Low Resolution
 Acromag Channel

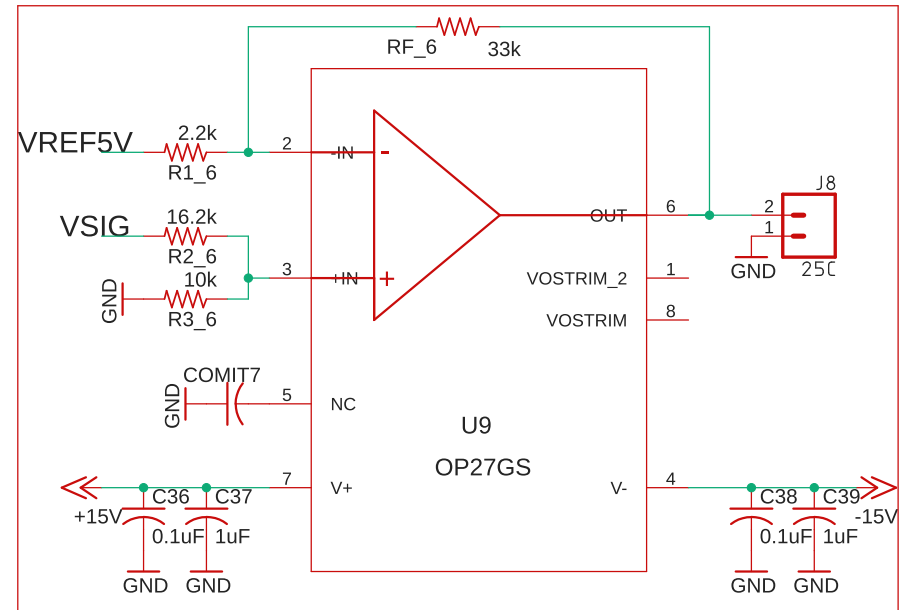
There is an error in this schematic.
 RTD should be directly connected
 to InAmp.
 Use latest DCC doc.
